## General Manager Report May, 2018

### City of Long Beach Future Service Area:

**WATER SYSTEM PLAN  
FIGURE 1-6  
WATER SYSTEM BASEMAP**

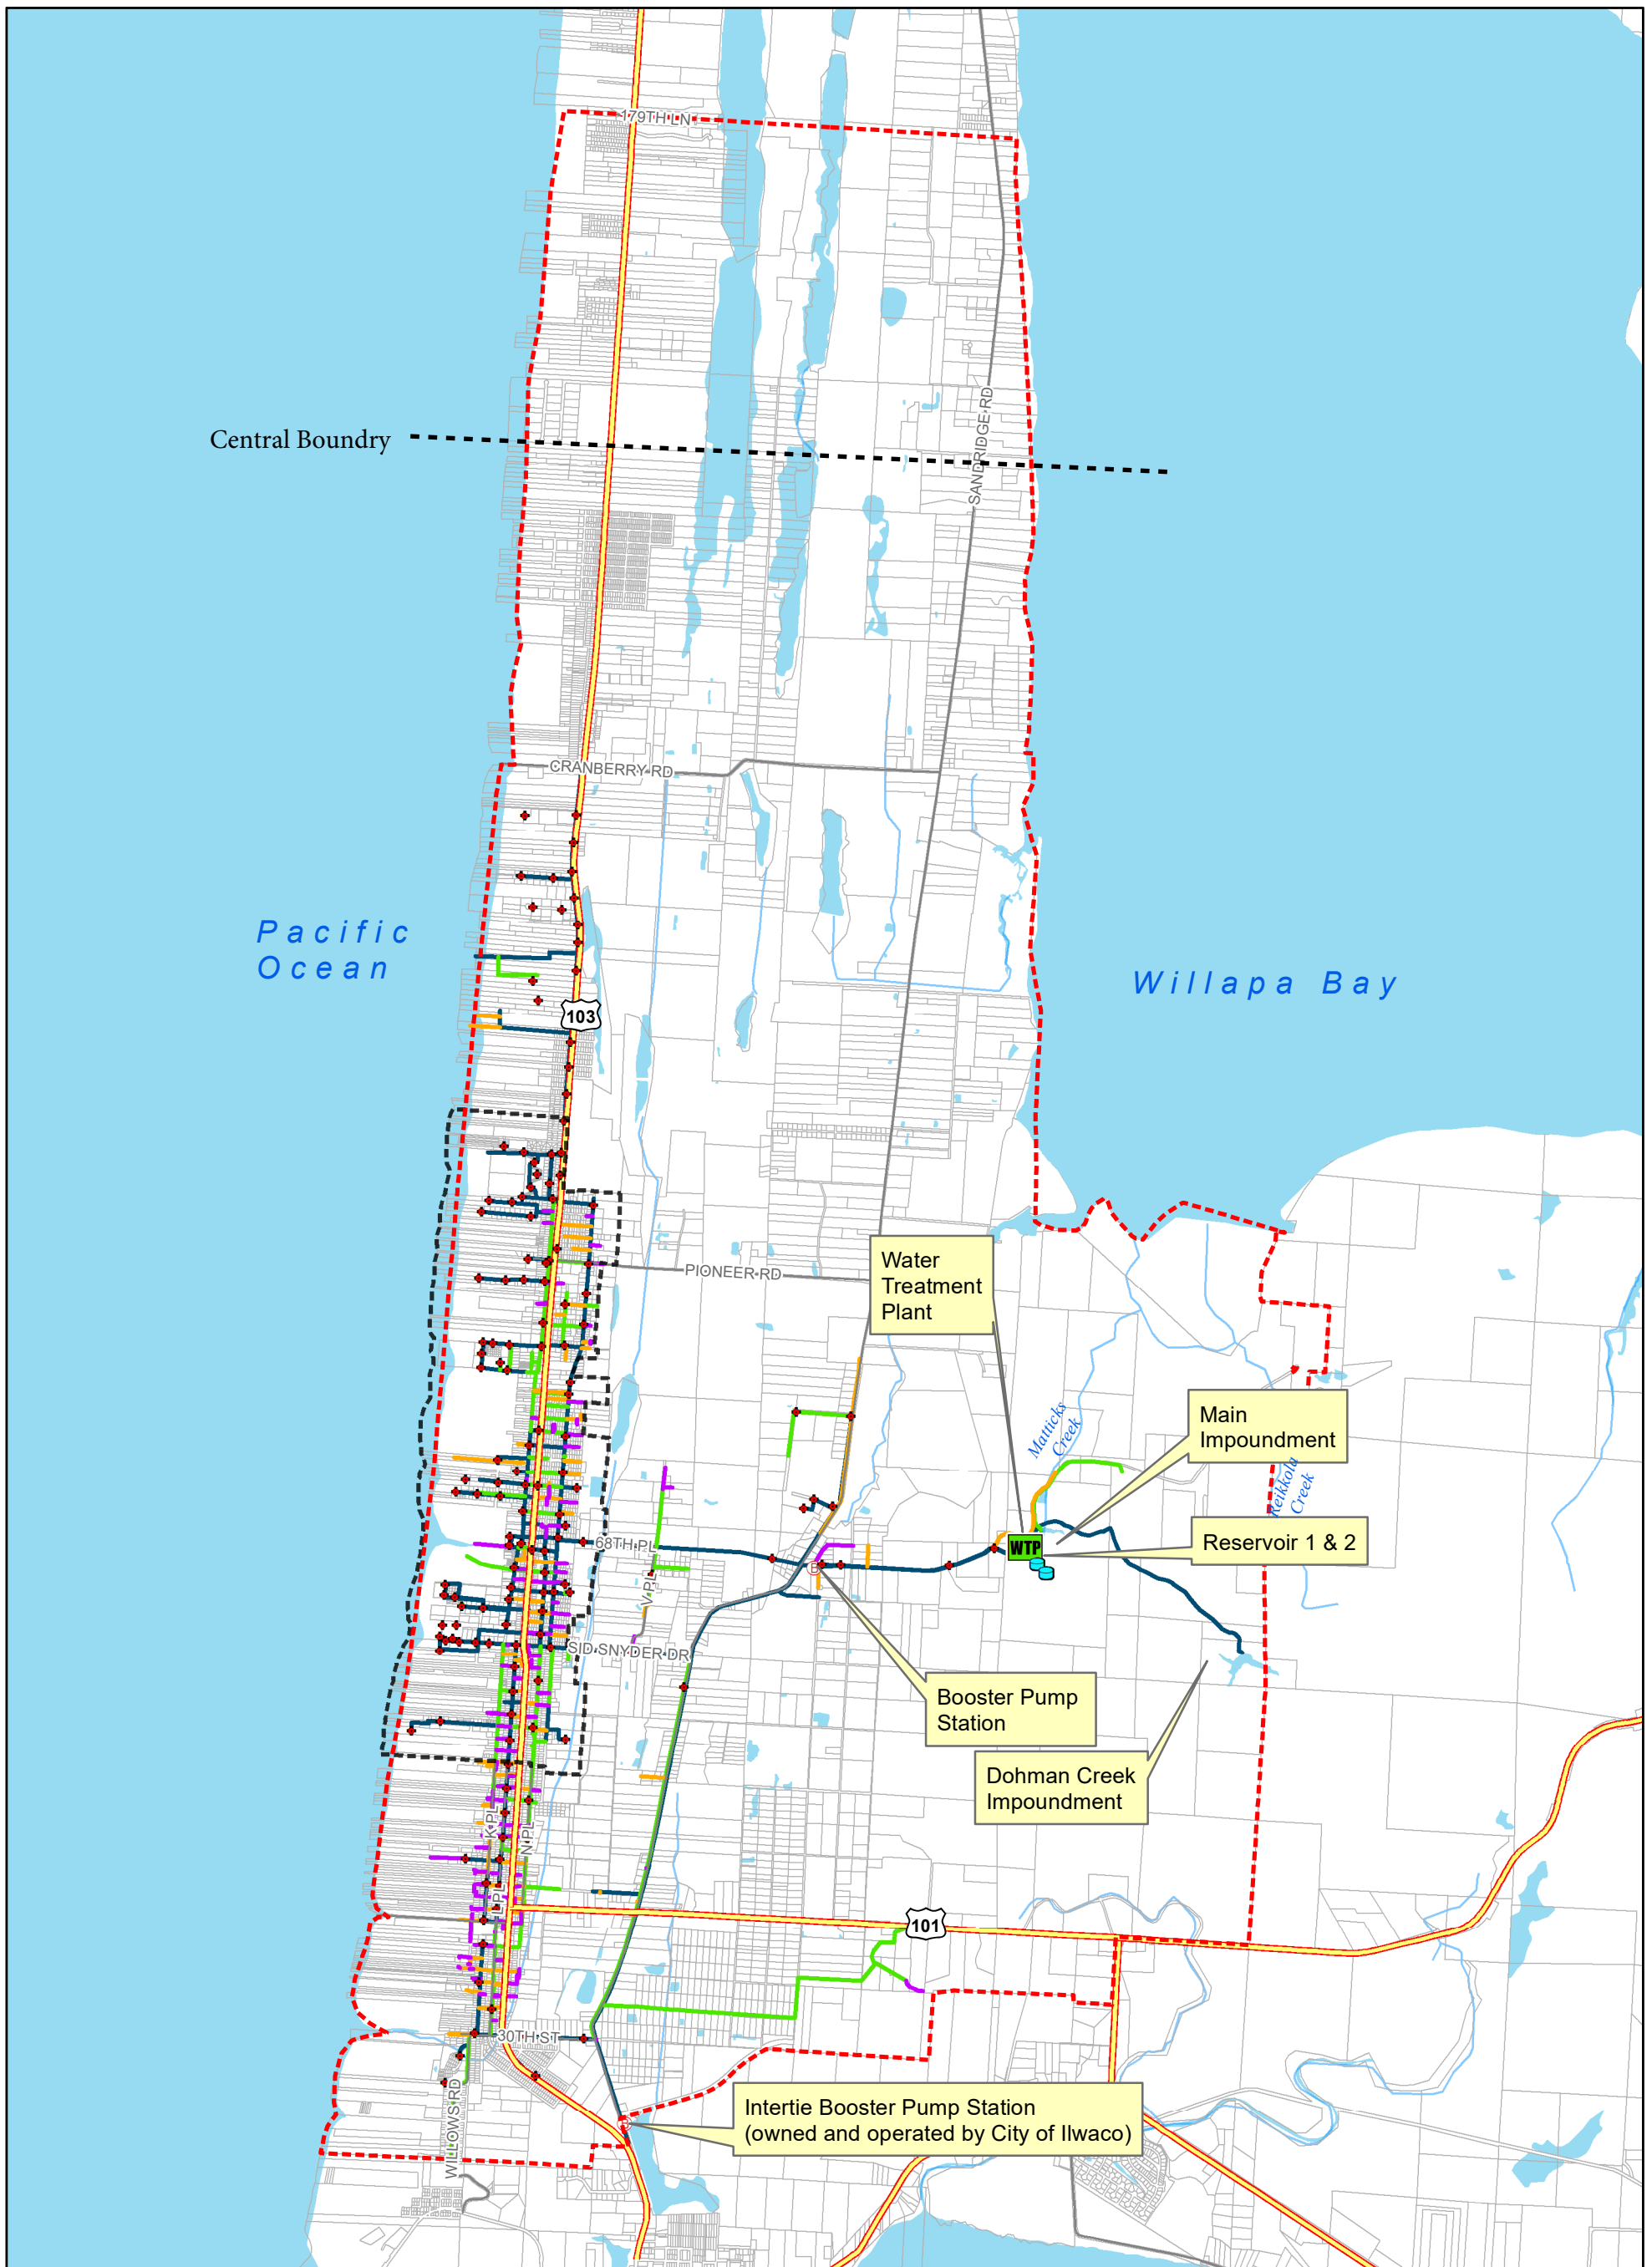
David Glasson contacted me concerning a revision to their Water System Plan. The City would like to expand their future service area to include area that is currently included in North Beach Water District's future service area.

I have included a map from the City. Currently, everything north of Cranberry Road is in the District's future service area.

Although I do not have a problem with this request I am concerned about the placement of their northern border.

The City's water main ends just south of Cranberry Road. The District's water main ends just north of 179<sup>th</sup> Lane. It would be much more reasonable to place the boundary about halfway between the District's and the City's water mains.
